**ZONING AMENDMENT &  
SUBDIVISION STAFF REPORT****Date: September 7, 2017**

<b><u>NAME</u></b>	Liberation Properties LLC
<b><u>SUBDIVISION NAME</u></b>	Bucknell Subdivision
<b><u>LOCATION</u></b>	7681 Old Shell Road and 7660 Monk Avenue (Area bounded by Old Shell Road, Monk Avenue, Alverson Road North and Harding Boulevard)
<b><u>CITY COUNCIL DISTRICT</u></b>	District 7
<b><u>PRESENT ZONING</u></b>	R-1, Single-Family District
<b><u>PROPOSED ZONING</u></b>	B-3, Community Business District
<b><u>REASON FOR REZONING</u></b>	To allow the construction of a medical office and a coffee shop.
<b><u>AREA OF PROPERTY</u></b>	1 Lot / 1.5 $\pm$ Acre
<b><u>CONTEMPLATED USE</u></b>	Subdivision approval to create 1 lot and Rezoning from R-1, Single Family District to B-3, Community Business District, to allow the construction of a medical office and coffee shop. <b>It should be noted, however, that any use permitted in the proposed district would be allowed at this location if the zoning is changed. Furthermore, the Planning Commission may consider zoning classifications other than that sought by the applicant for this property.</b>

# SITE PLAN

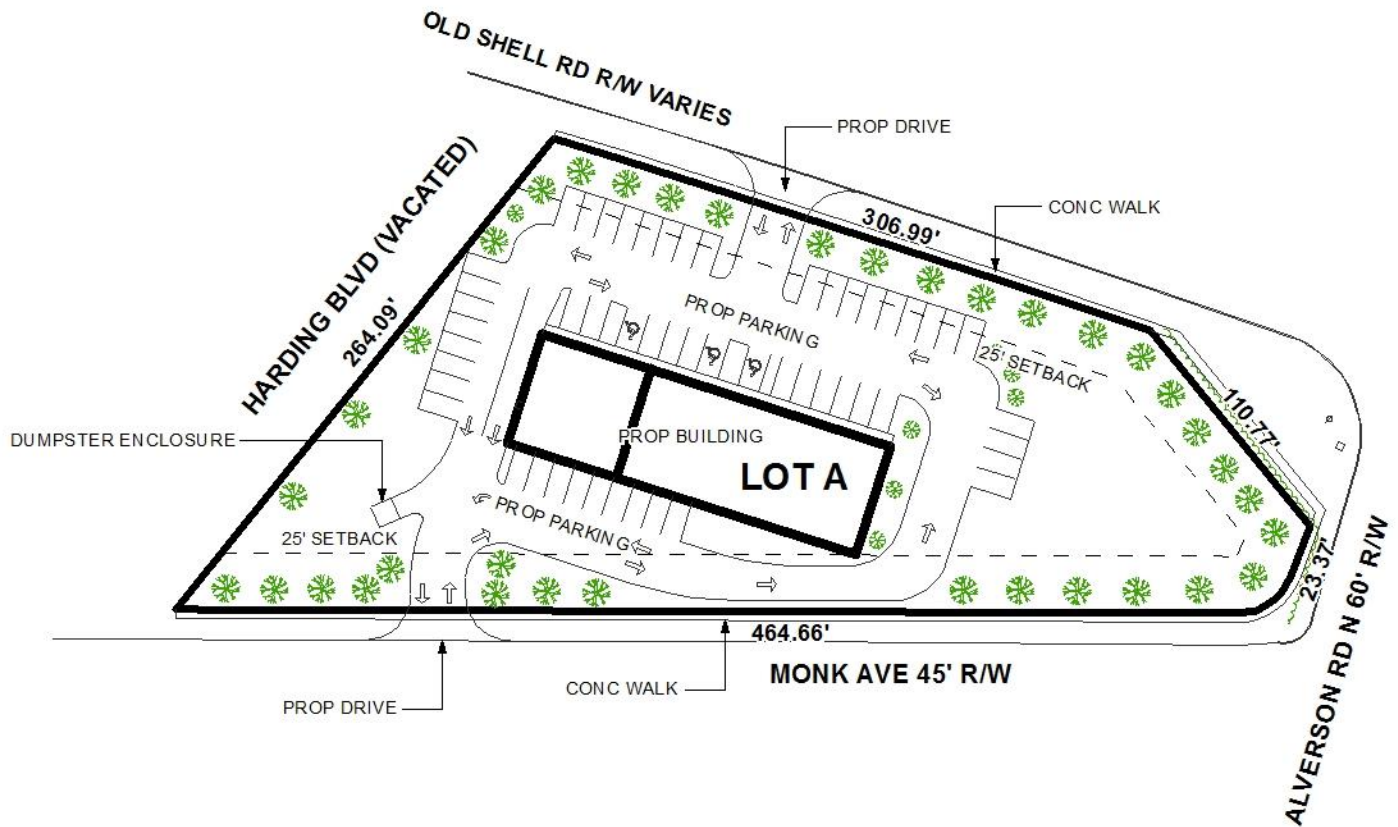
The proposed layout for development depicts a multi-tenant space. The applicant is proposing a 2,500 square foot coffee shop with a drive-through as well as a proposed 5,500 office building. 52 parking spaces have been provided on site with compliant 24' access aisles. Only two curb cuts have been provided on site, one to Monk Avenue and one to Old Shell Road.

The site plan submitted provides tree and landscape calculations. A site plan depicting full tree planting and landscaping requirements per Section 64-4.E of the Zoning Ordinance will also be required at the time of submission for building permits.

A dumpster with an enclosure is depicted on the site plan. If approved, dumpster placement must comply with Section 64-4.D.9. of the Zoning Ordinance.

A 4' sidewalk is shown on the site plan along Old Shell Road, Alverson Road North, and Monk Avenue.

- 8) Compliance with Traffic Engineering comments: *“(Site is limited on one curb cut to Old Shell Road and one curb to Monk Avenue with size, location and design to be approved by Traffic Engineering and conform to AASHTO standards. Site is denied access to Alverson Road. On-site parking, including ADA handicap spaces, shall meet the minimum standards as defined in Section 64-6 of the City’s Zoning Ordinance.)”;*
